PTS STANDARDS - 100 SERIES DRAWINGS
STANDARDS FOR ROADWAY CONSTRUCTION
APRIL 2022 EDITION – CHANGE NO. 2 – NOVEMBER 2023

PTS – 100 SERIES DRAWINGS

PENNSYLVANIA TURNPIKE COMMISSION
INDEX OF STANDARDS FOR ROADWAY CONSTRUCTION

FILE NAME: PTS-130-2.dwg
 DRAWING TYPE: 5A

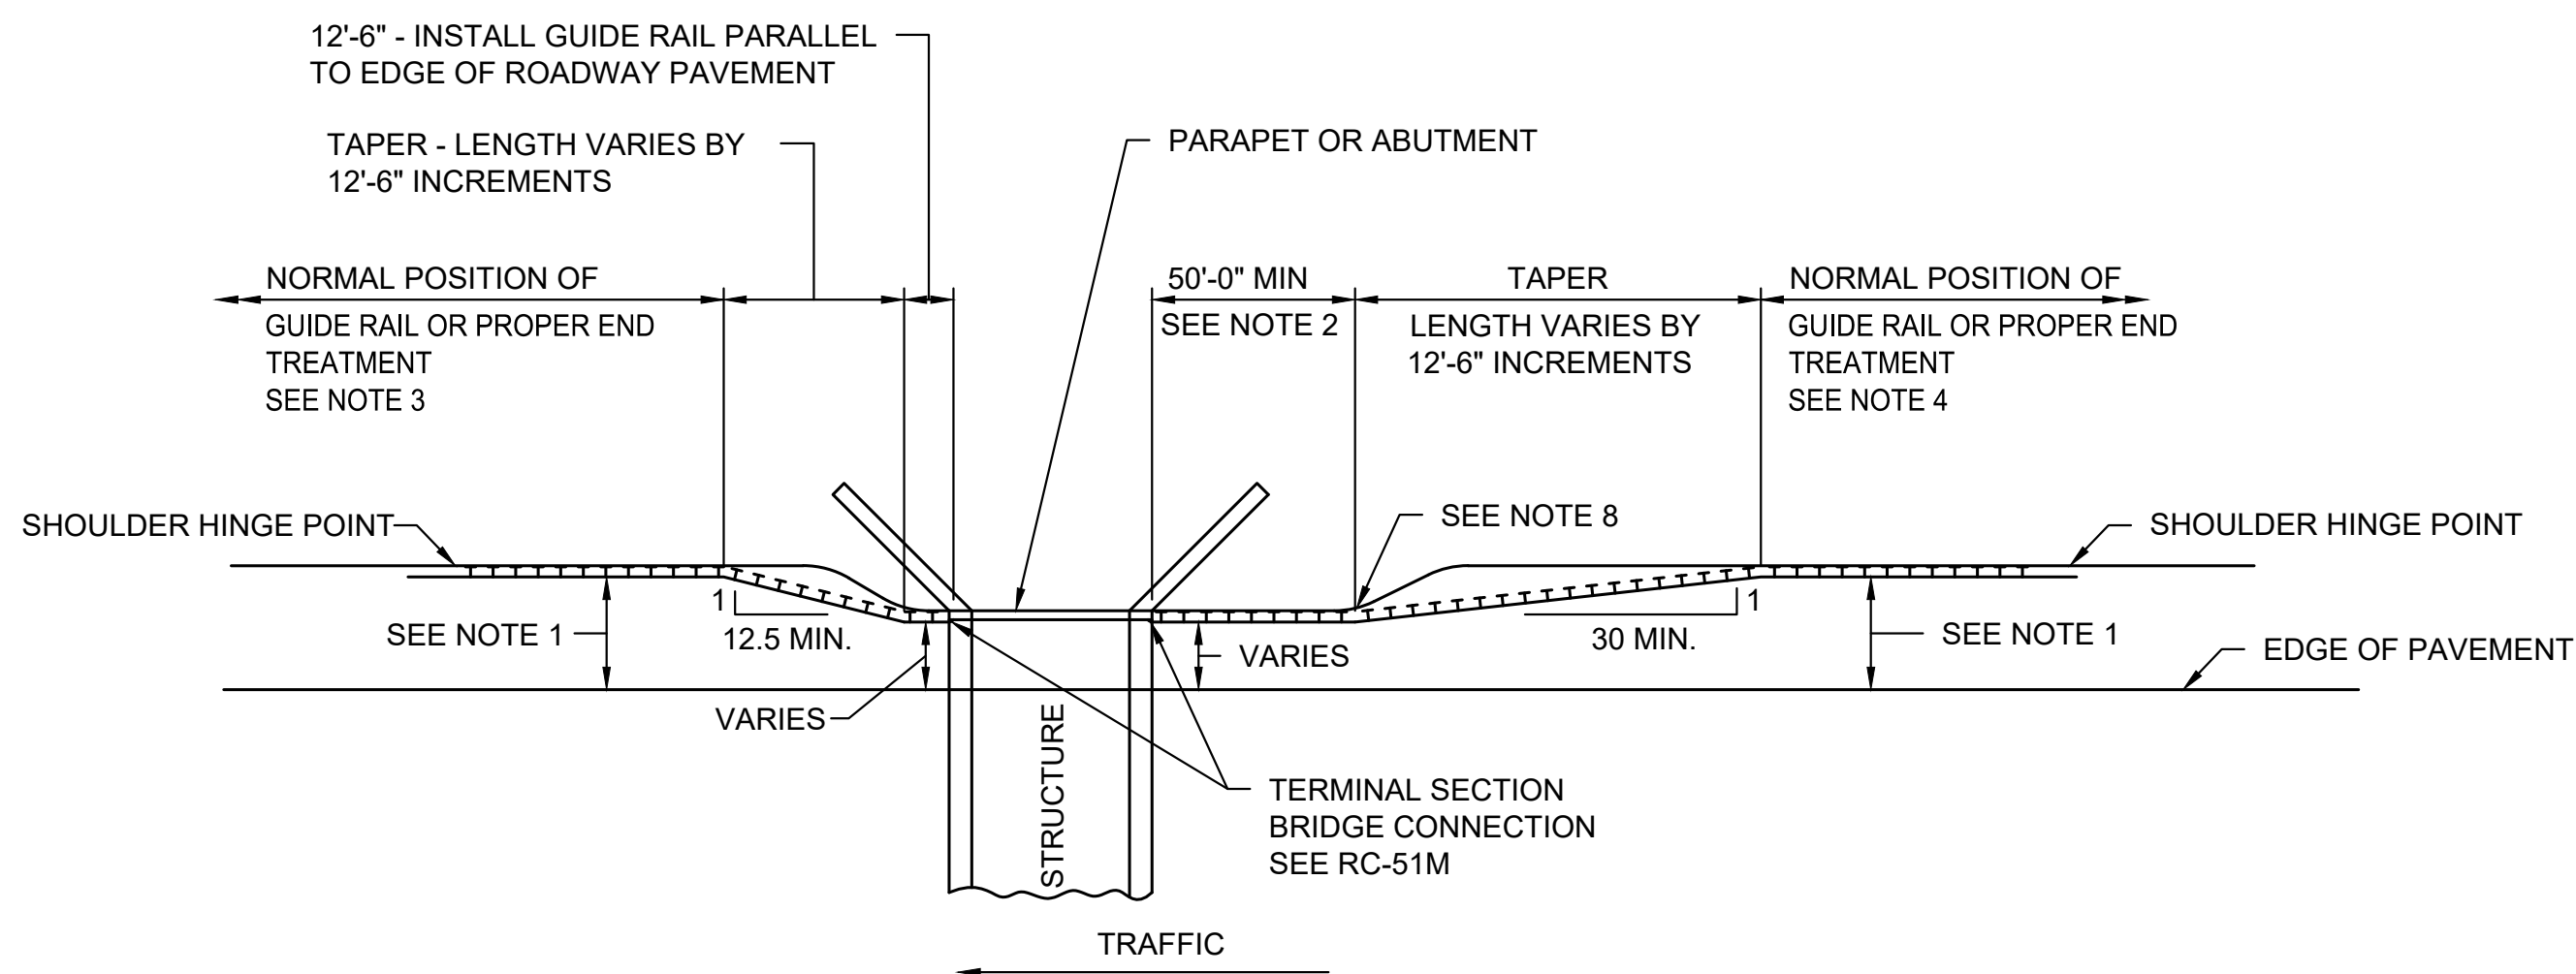
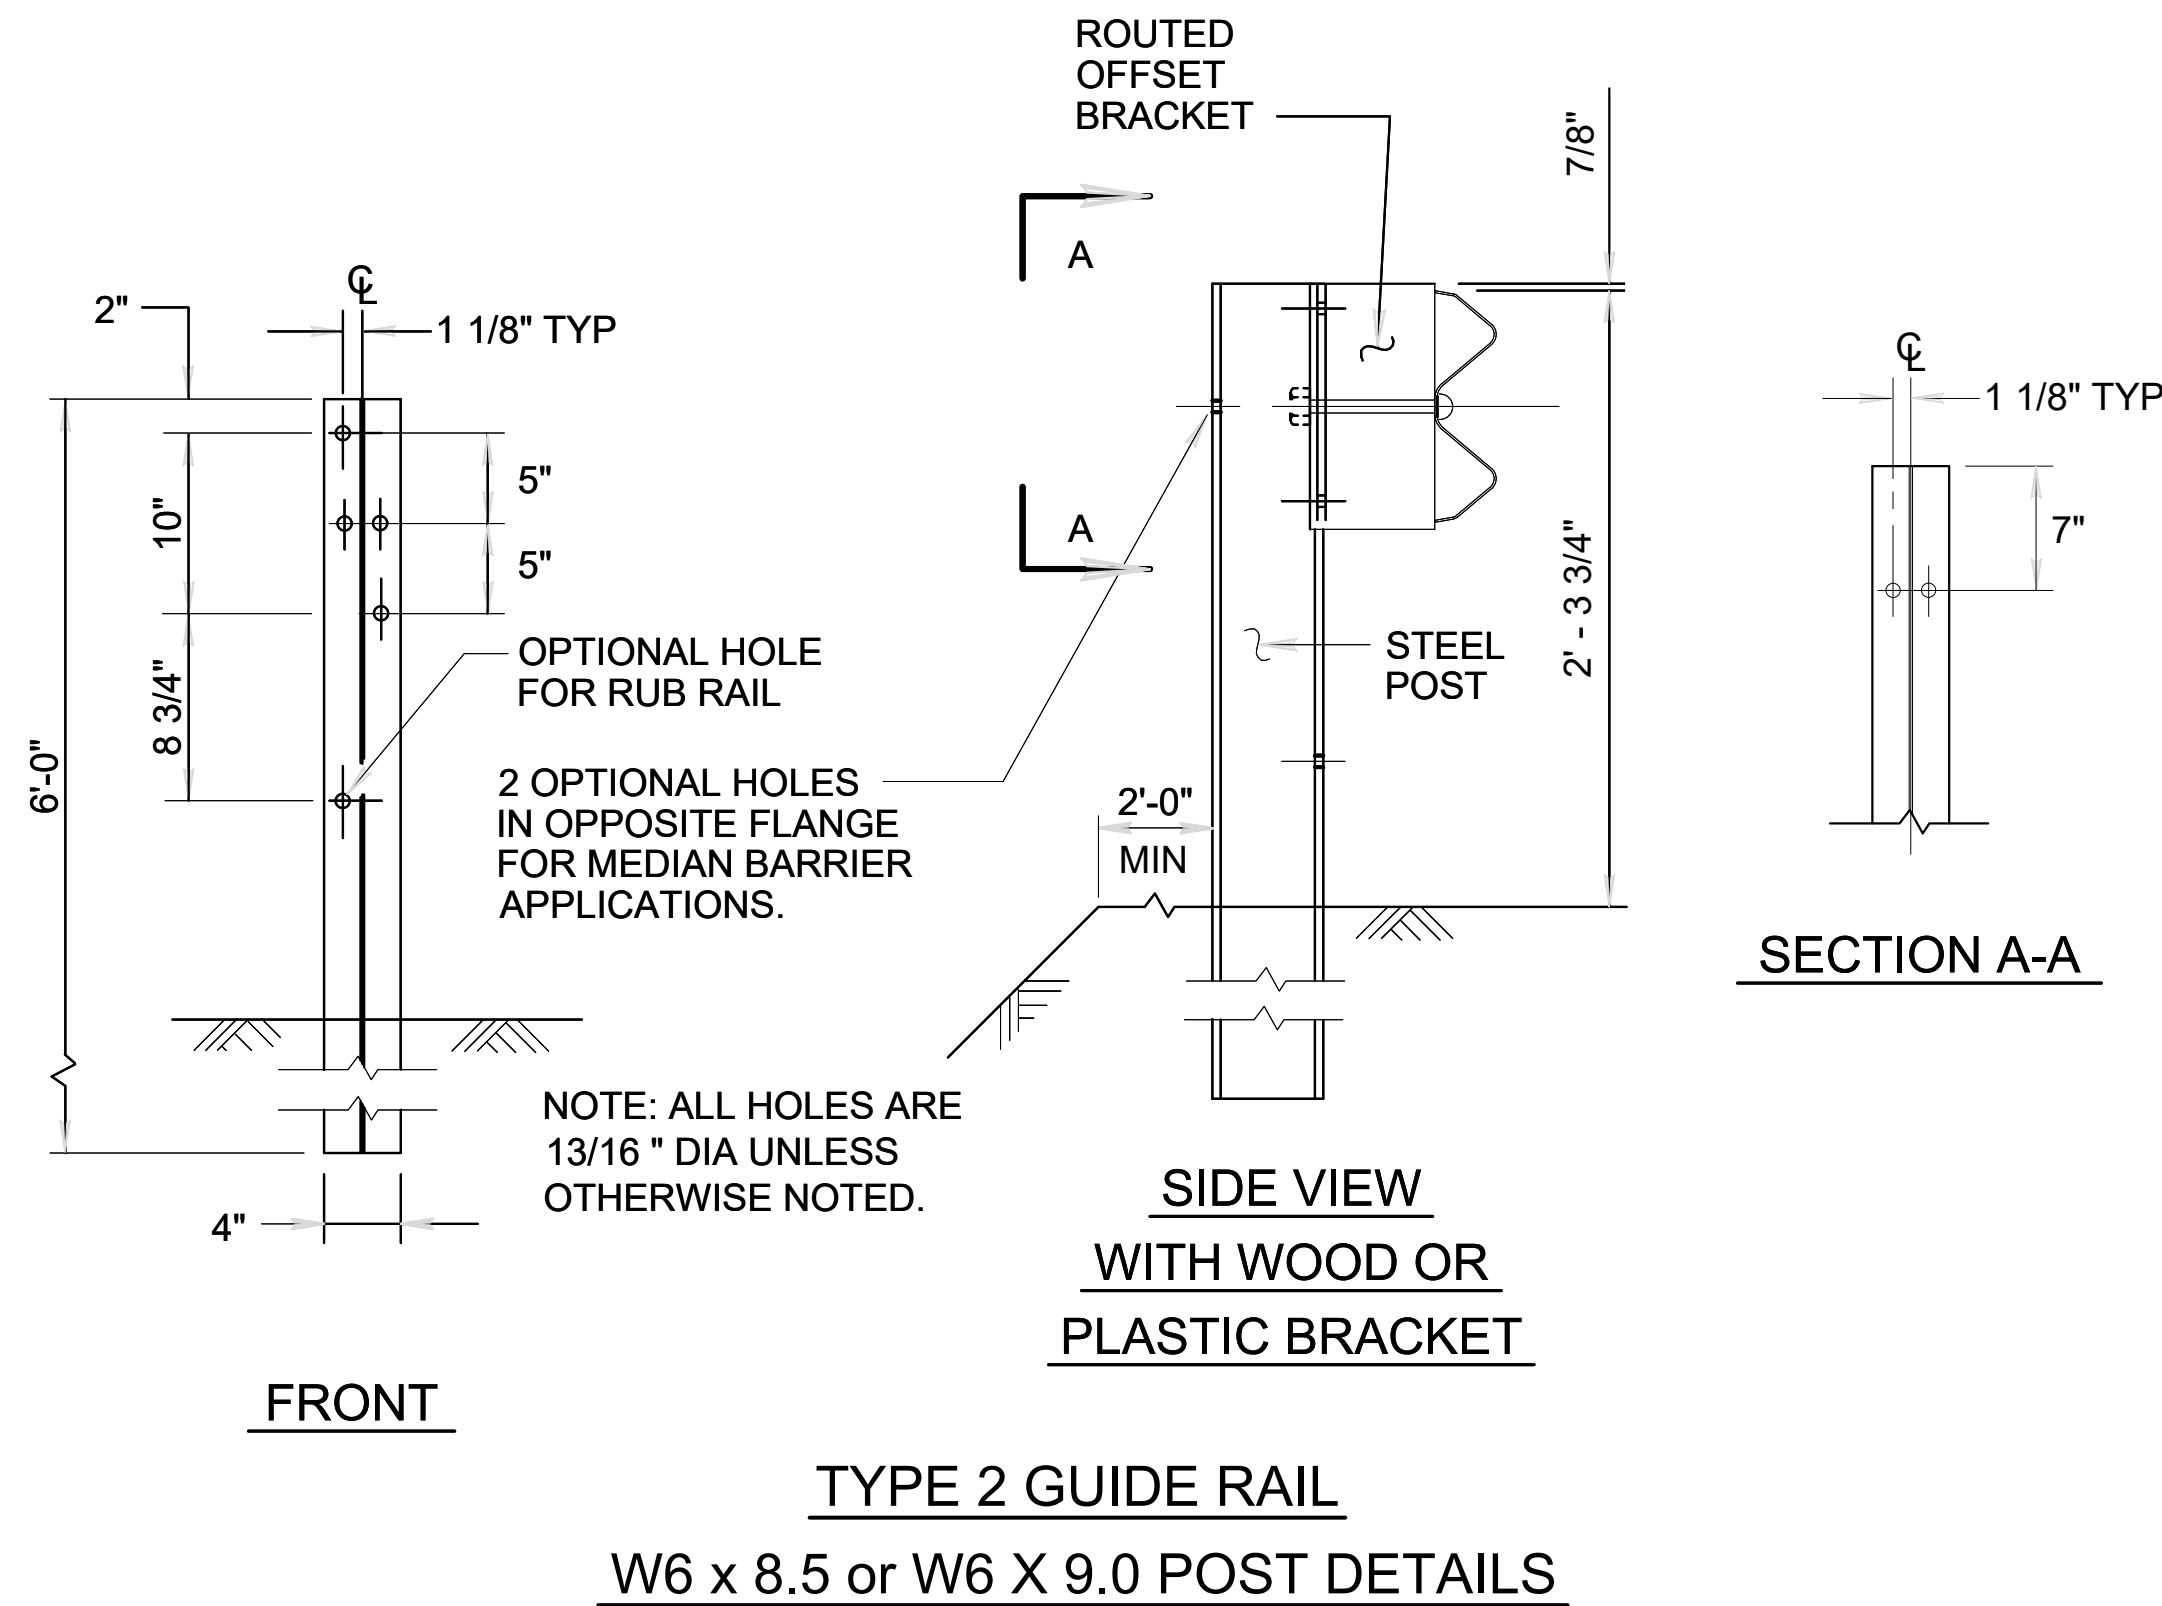
ADDED TEXT TO NOTE 4. REVISED PLAN VIEW DETAILS TO ALIGN RAIL WITH STRUCTURE.

FILE NAME: PTS-140-2.dwg
DRAWING TYPE: 5A

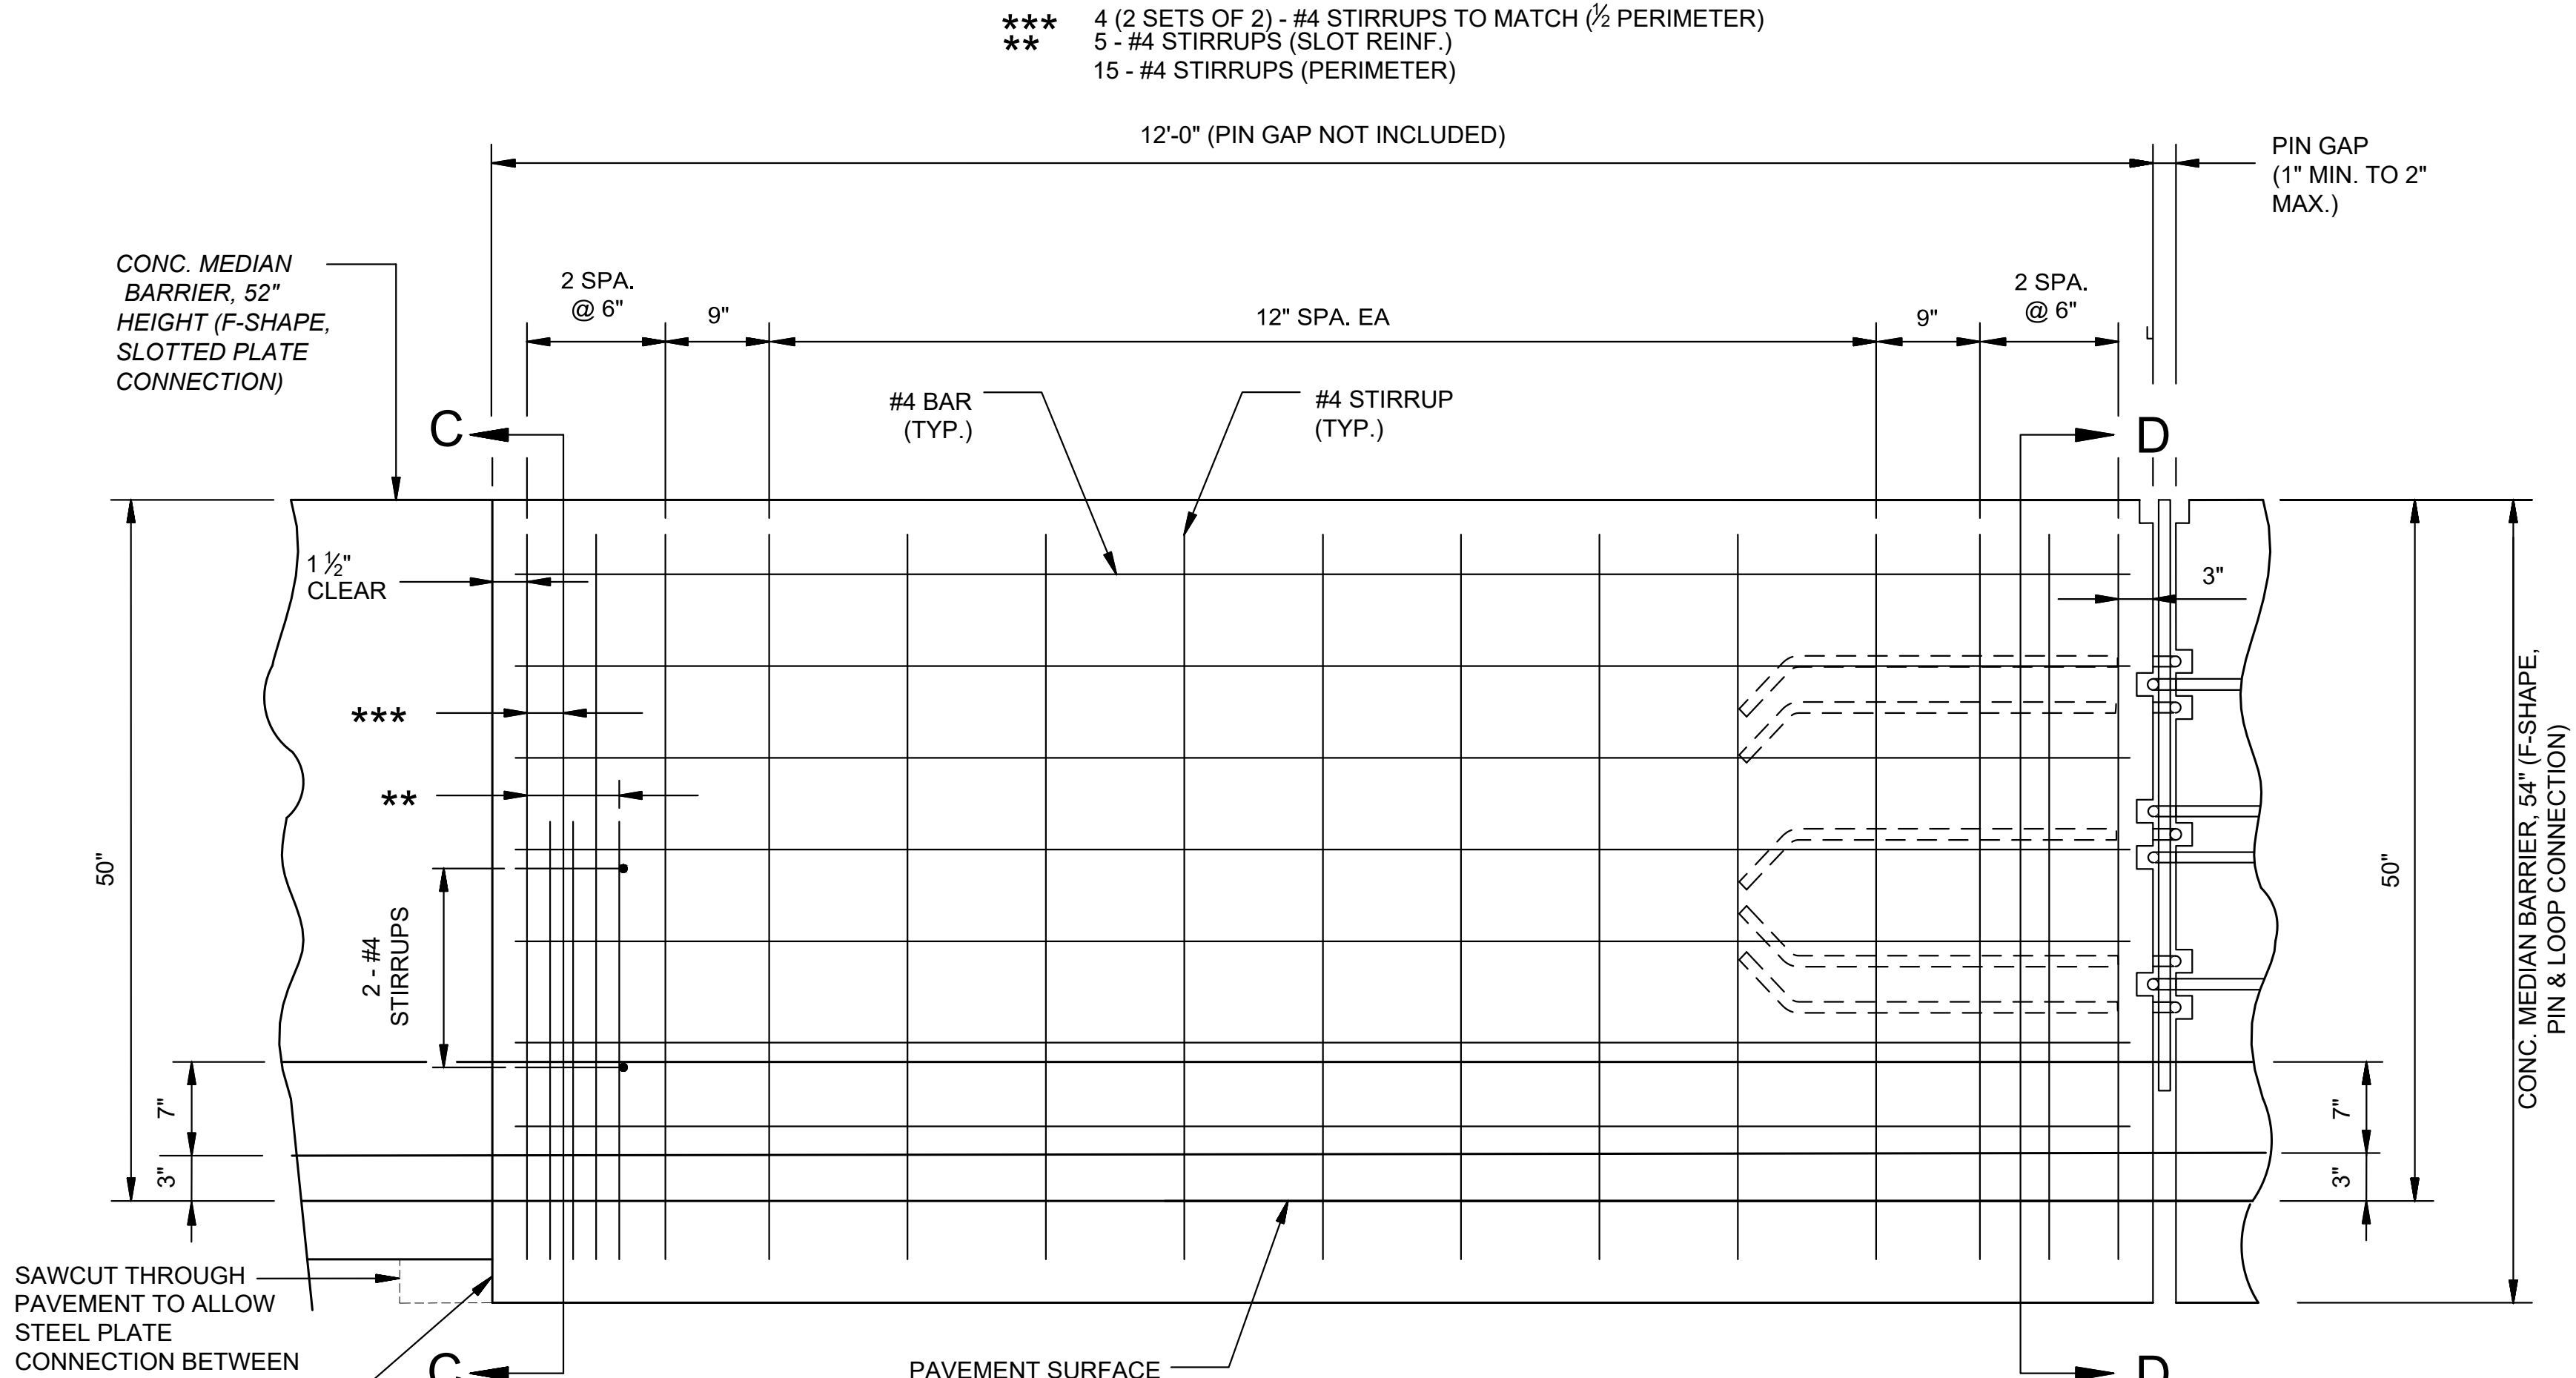
REVISED NOTE FOR SLOTTED PLATE CONNECTION AND INDICATED SLOT DETAILS.
